1 Products affected:

All KG and CG power entry modules KGXX.XXXX.XXX
CGXX.XXXX.XXX

2 Type of change :

Socket and filtercase modification

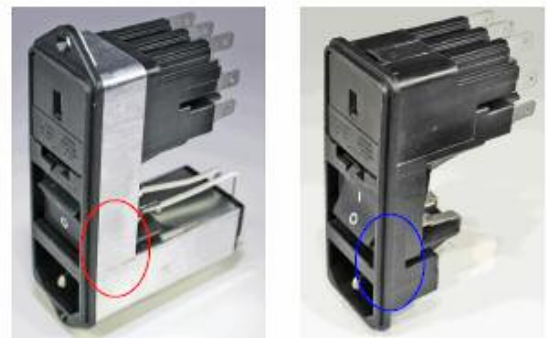
KG : Reinforcement between inlet and switch
CG : Filtercase is made in one piece

Improved evenness of socket-flange
